Access Compliance Report Public Rights-of-Way (Curb Ramps)

Cross Street: PARK RD Intersection ID: 18488 Main Street: ABBEY PL Location: NW

Initial Pass/Fail: Fail **Overall Compliance: No** ADA ID: C5B42B7EEC3E Ramp Type: Perp Severity Score: 13.75

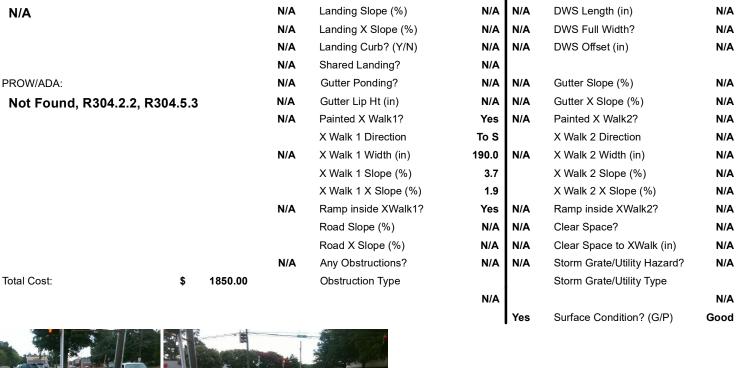
| 1 | Possible Solutions: | Compli | ance | Description |
|---|-------------------------------|--------|---------------|-----------------|
| | Not Found, R304.2.2, R304.5.3 | N/A | Gutte | r Lip Ht (in) |

| 1 | Possible Solutions: | Compli | ance | Description |
|---|-------------------------------|--------|---------------|-----------------|
| 1 | Remove & Replace Entire Ramp. | N/A | Ramp | Length (in) |
